Table 1: Responses to Comments from Government Department on Planning Application No. A/NE-LYT/816 (19 February, 2024)

Figure 4A – Layout Plan showing the Pedestrian Route

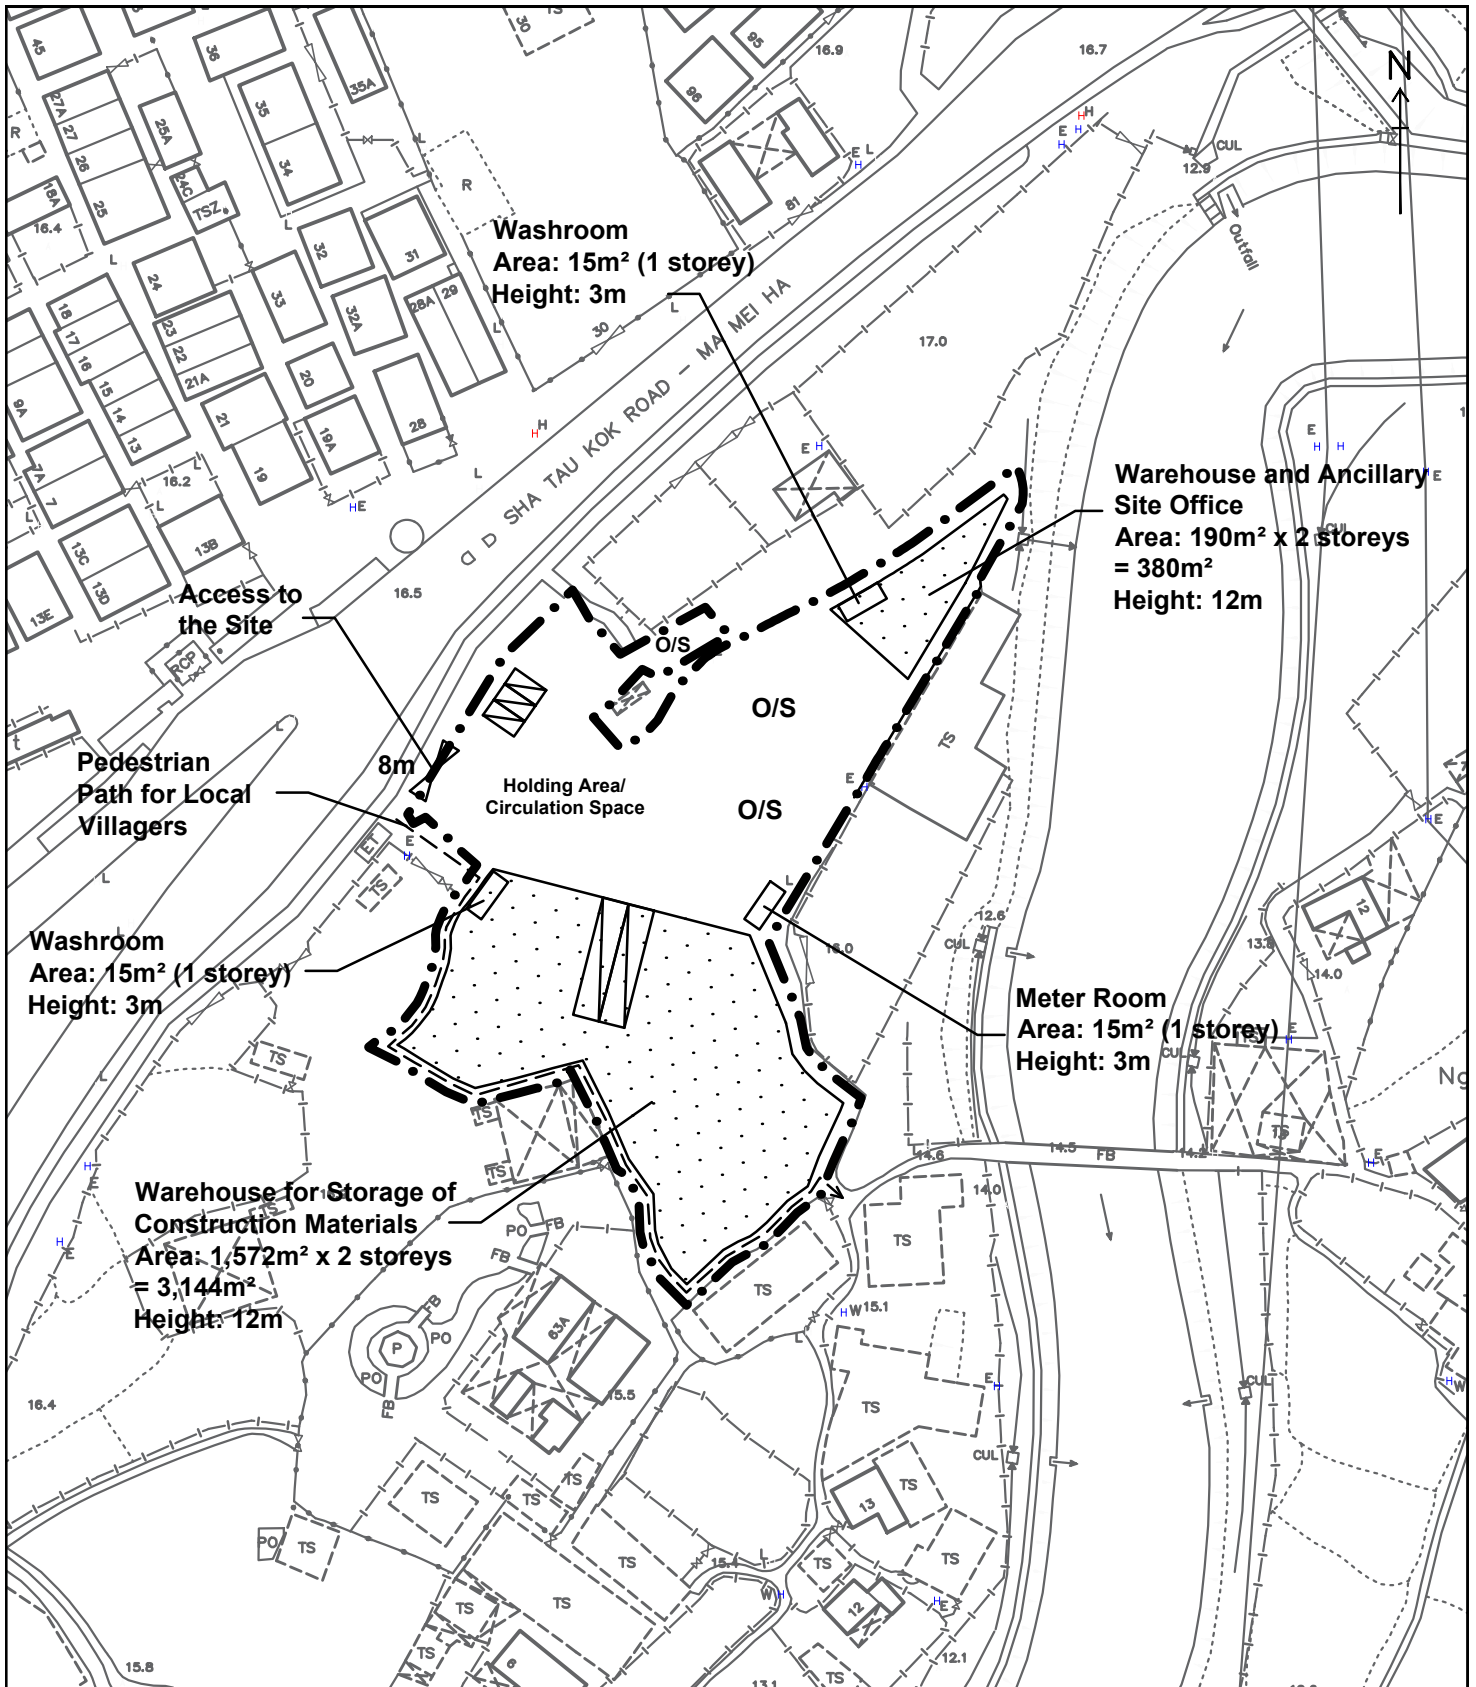
COMMENTS	RESPONSES
<p>1. Sha Tin, Tai Po and North District Planning Office, Planning Department</p>	
<p>(a) According to the Planning Statement, the application site is proposed to be used as temporary warehouse and open storage of construction materials, which would be fenced off by corrugated metal sheets on all sides. Please advise how the access of emergency vehicles and pedestrian from Sha Tau Kok Road – Ma Mei Ha to the village settlements in Ng Uk Tsuen would not be interrupted by the proposed use. Public comments received during the statutory public inspection period raising similar concerns are also attached (Appendix A) for your reference.</p>	<p>(a) A pedestrian access/path will be reserved with the Application Site for local villagers from Sha Tau Kok Road – Ma Mei Ha to the village settlements in Ng Uk Tsuen (see Figure 4A at Annex 1). Meanwhile, it is worth note that no emergency vehicle access was provided in the past and emergency vehicles are not using the private land within the Application Site. The Applicant will continue to allow the refuse collection vehicles to access the site and collect the refuse at the villagers’ waste collection point at regular time interval. As such, the pedestrian access would not be interrupted by the proposed development.</p>

Figure 5 – Landscape and Tree Preservation Proposal and Existing Tree Photos

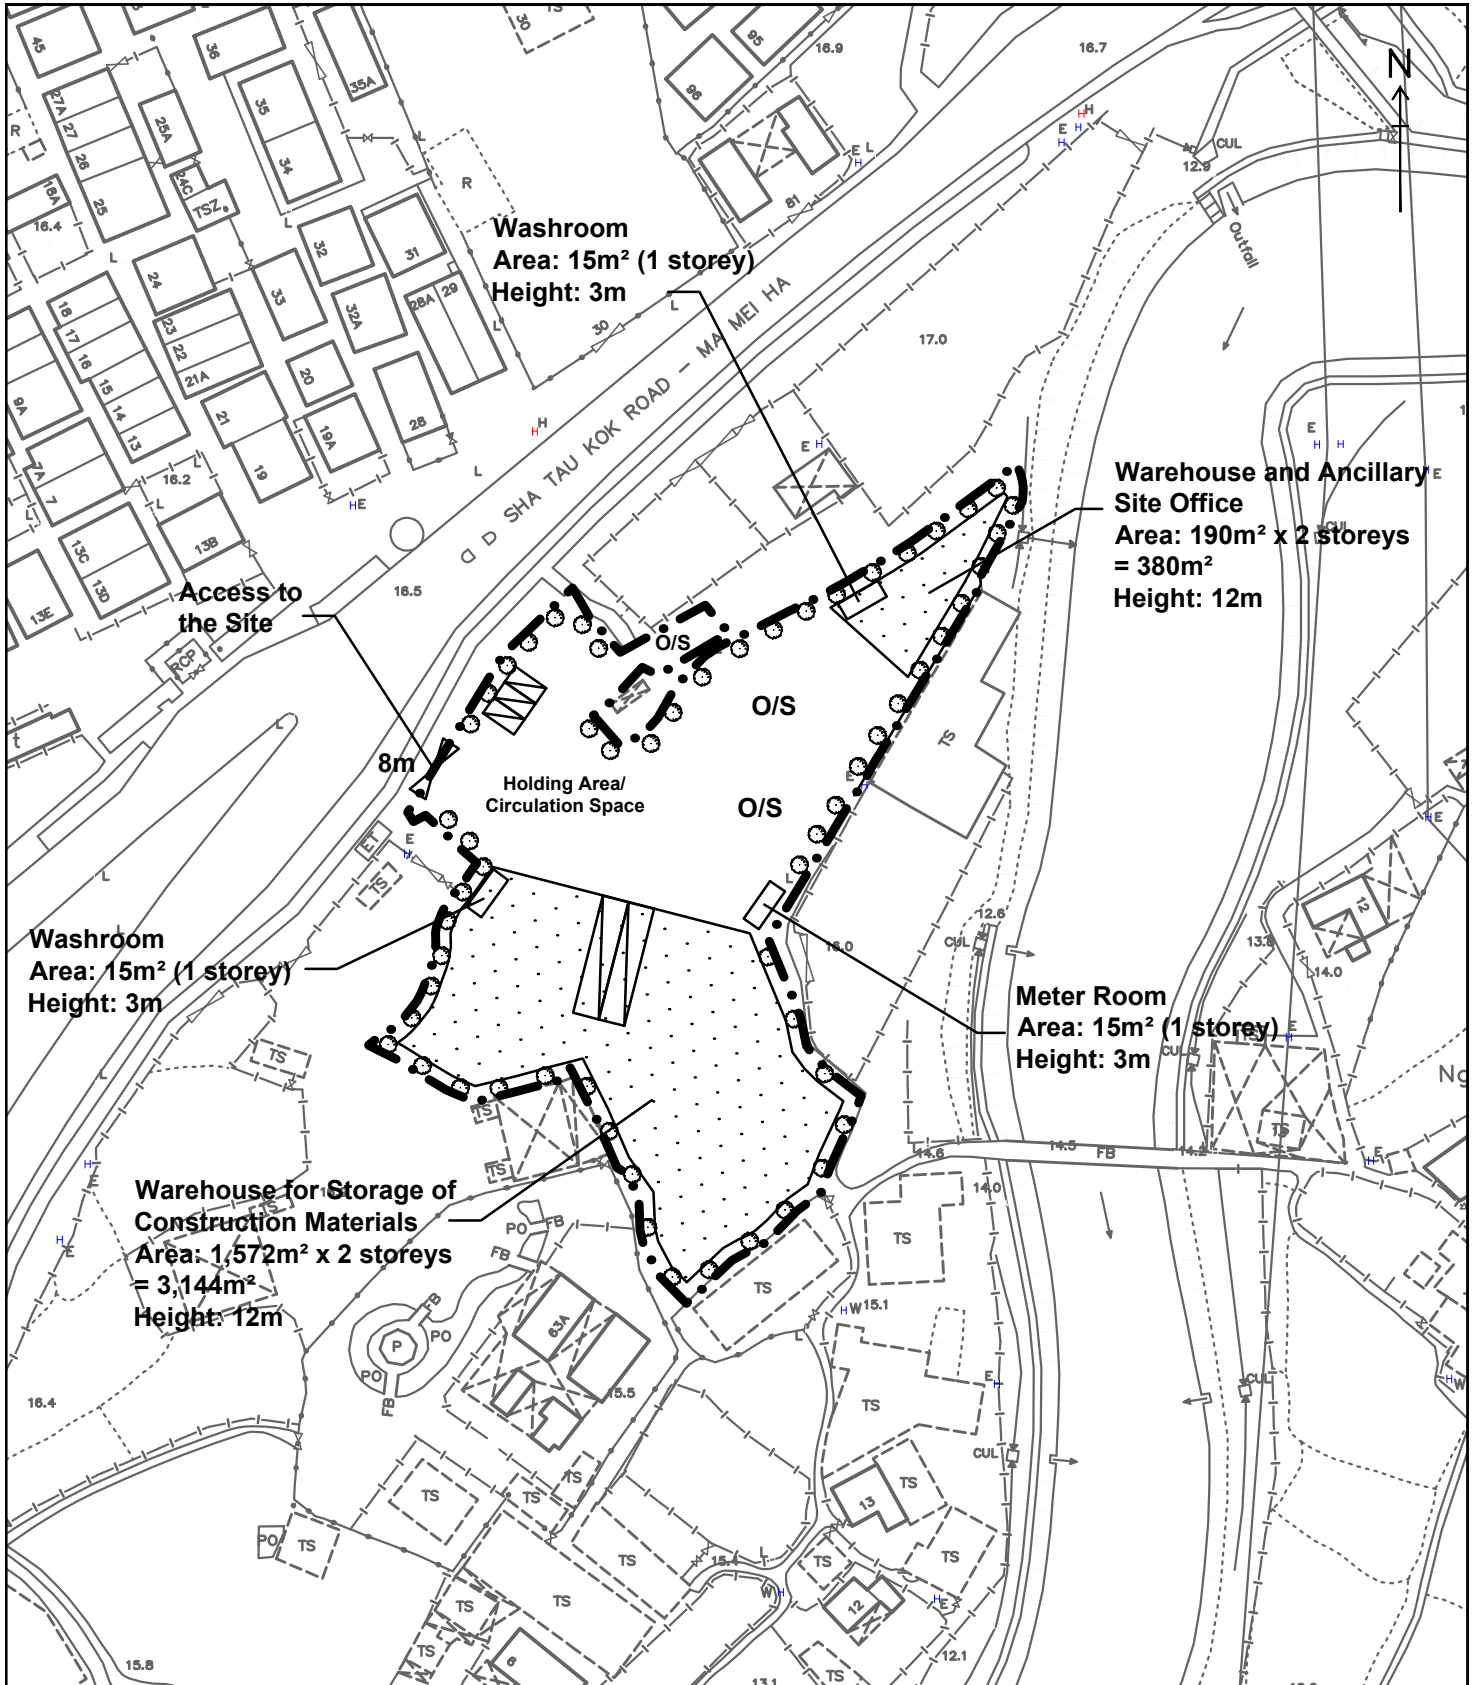
<p>2. Urban Design & Landscape Section, Planning Department</p>	
<p><u>Landscape Observations / Comments</u></p> <p>(a) With reference to the aerial photo of 2022, the site is located in an area of rural inland plains landscape character comprising of clusters of small houses, temporary structures, vehicle parks, and clusters of tree groups. The site is hard paved and some trees of common species are observed along the site boundary within the site. According to the Planning Statement, 51 nos. of existing trees (i.e. Ficus Microcarpa) along the site boundary would be preserved as far as practical. According to the Layout Plan, the proposed layout will be in</p>	<p>(a) According to our site visit on 8.1.2024, approximate 59 trees are found within the site (see Landscape and Tree Preservation Proposal at Annex 2). The trees are Ficus Microcarpa and in good conditions. All the existing trees are proposed to be preserved within the Application Site. The details of the existing trees (location and size) are shown in Figure 5 and photos showing the condition of existing trees are provided at Annex 2.</p> <p>All the structures are set back 2m from the site boundary to allow the</p>

COMMENTS	RESPONSES
<p>conflict with the existing trees. Without information (e.g. location, size, conditions and proposed treatment etc.) on the existing trees within the site, potential adverse impact on the landscape resources arising from the proposed use cannot be reasonably ascertained.</p>	<p>preservation of existing trees and provision of drainage facilities. Therefore, the proposed layout will not be in conflict with the existing trees.</p>
<p><u>Detailed Comments / Advisory Comments</u></p> <p>(b) The applicant should provide information (e.g. location, size, conditions and proposed treatment etc.) on the existing trees within the site, proposed tree treatment and mitigation measures, if any. The applicant is reminded to offset the proposed temporary structures and car parks from the existing trees to avoid damage to the trees.</p>	<p>(b) See our response in 2(a) above.</p>
<p>3. Highways Department</p>

Drawing No. STK 004

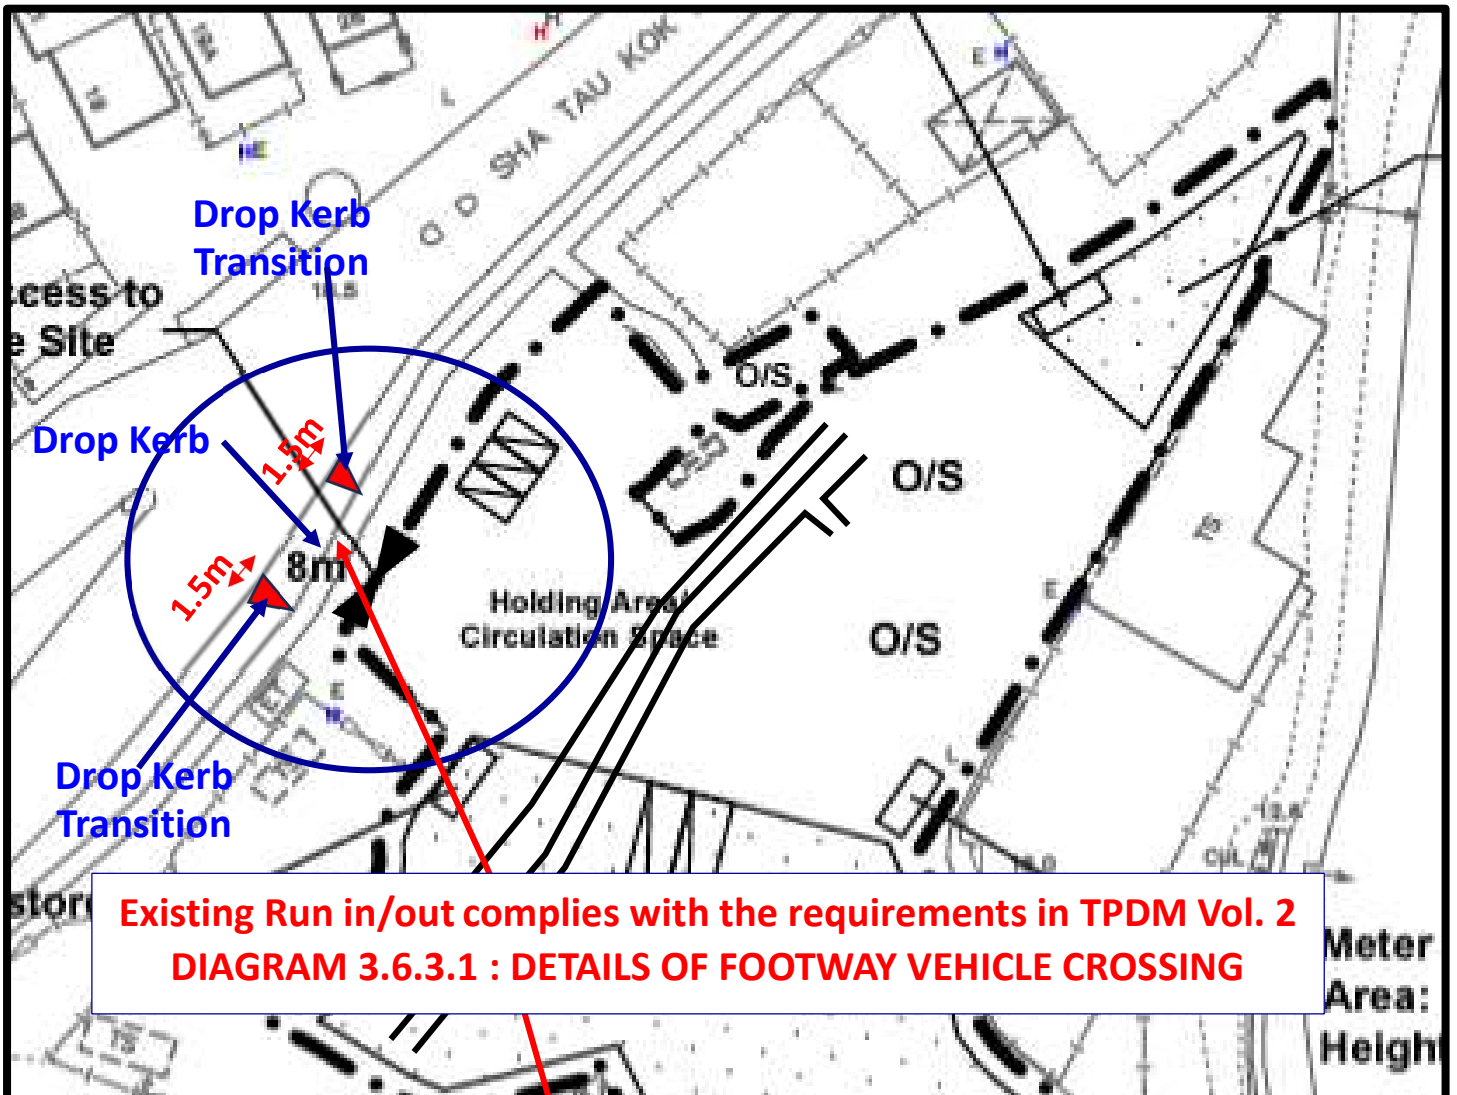
COMMENTS	RESPONSES
4. Transport Department	
(a) Please provide the detailed layout of run-in/out and ensure that it complies with the requirements in TPDM Vol. 2 Ch. 3.6; and	(a) Drawing No. STK004 is attached showing the existing drop kerb complies with TPDM – Diagram 3.6.3.1 (see Annex 3).

Openable Windows and Doors of the Proposed Warehouse

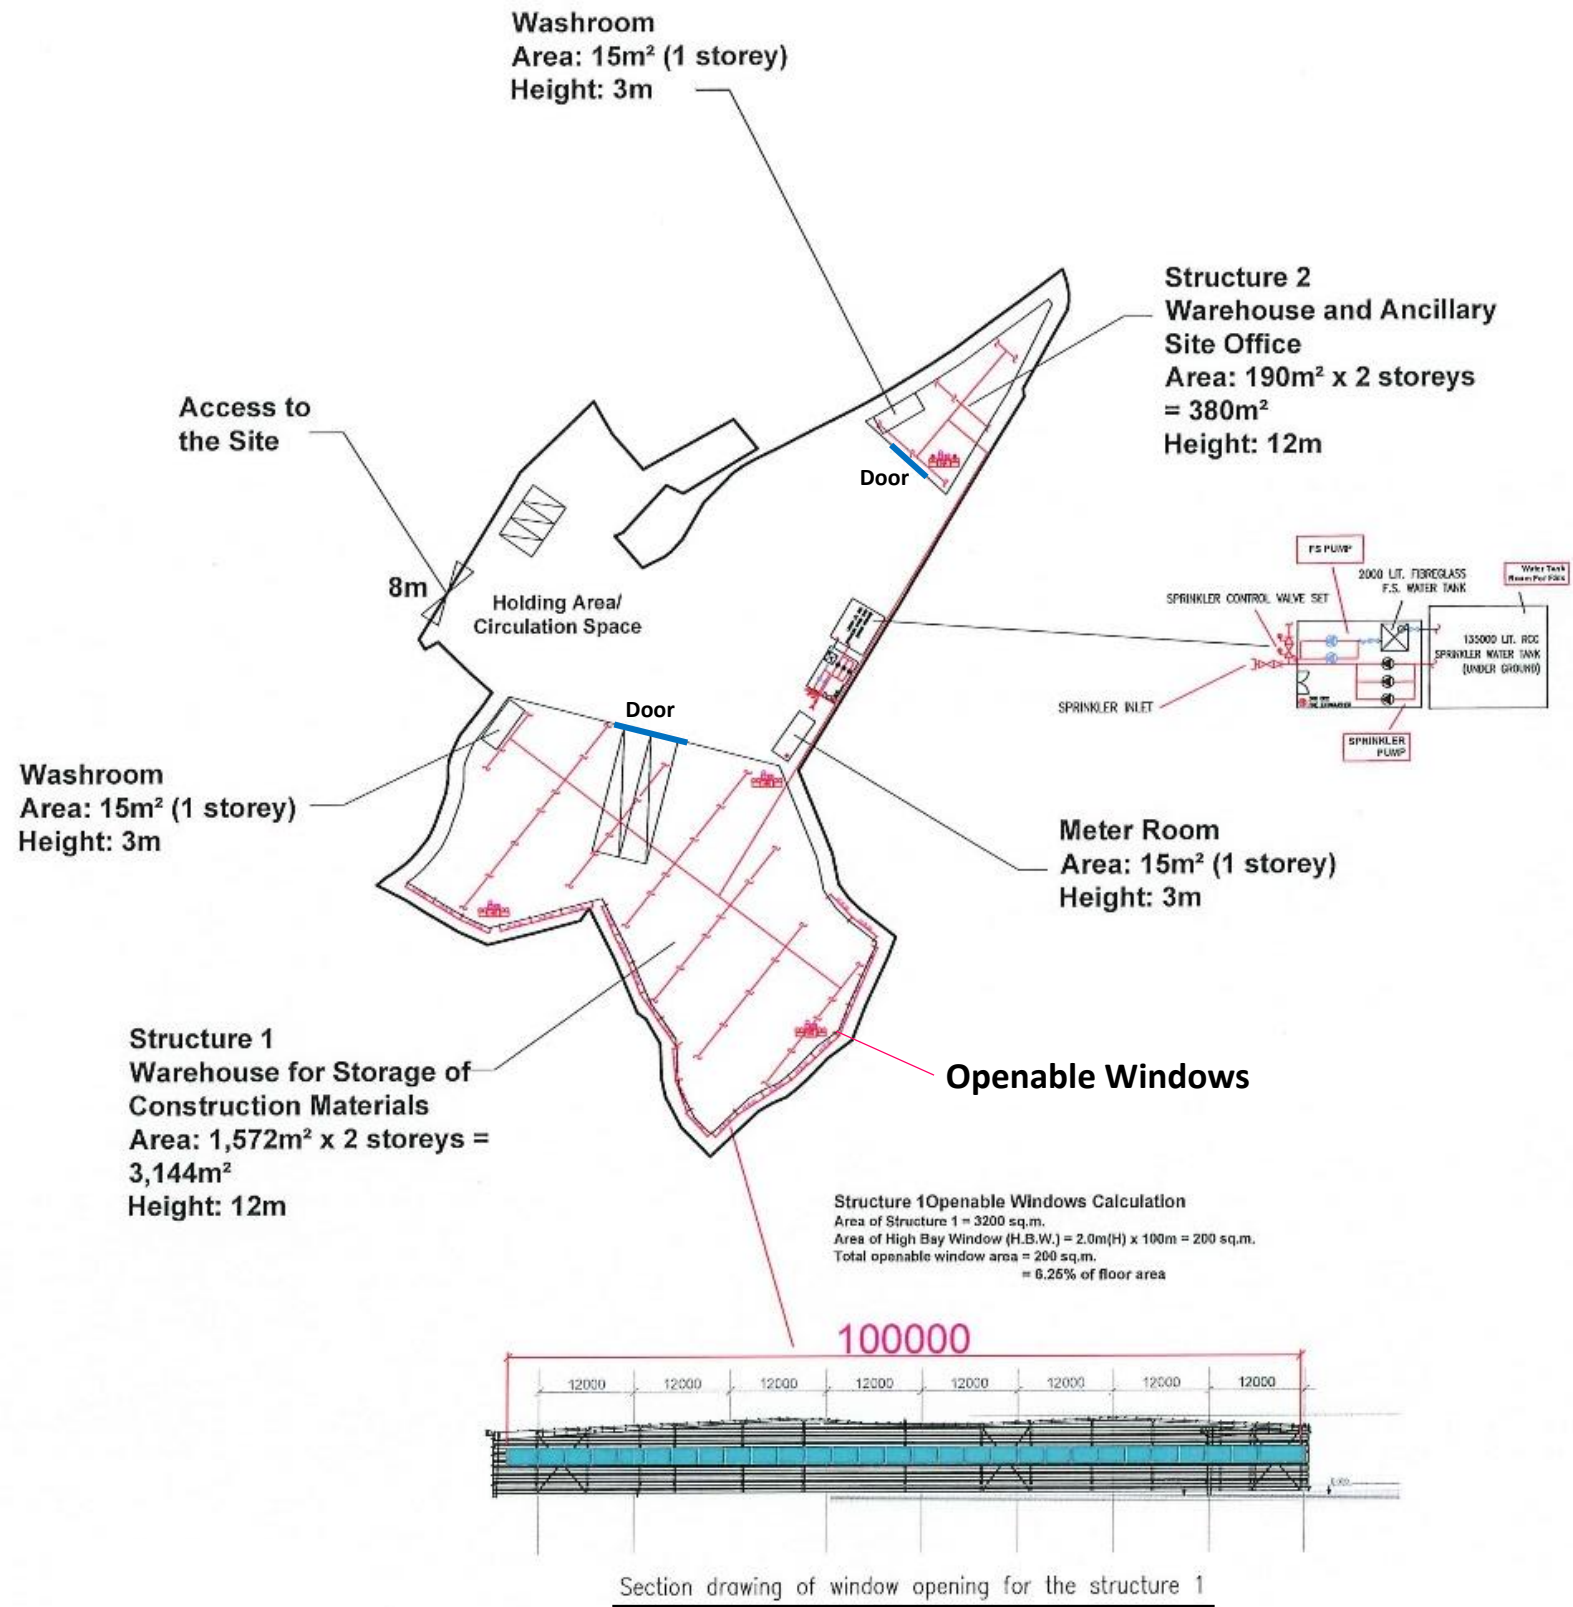
(d) Please clarify if the warehouses have any openings (including windows and doors). If yes, please indicate the location of all windows and doors on suitable plans;	(d) The proposed warehouse will provide 6.25% openable window area to meet openable windows requirements for fire safety purpose (the extract of the fire services installation proposal is attached at Annex 4 for reference). The windows will be kept closed at all time and a well-designed ventilation system will be provided to improve the indoor air quality. The doors of the warehouses were also marked on the plan.
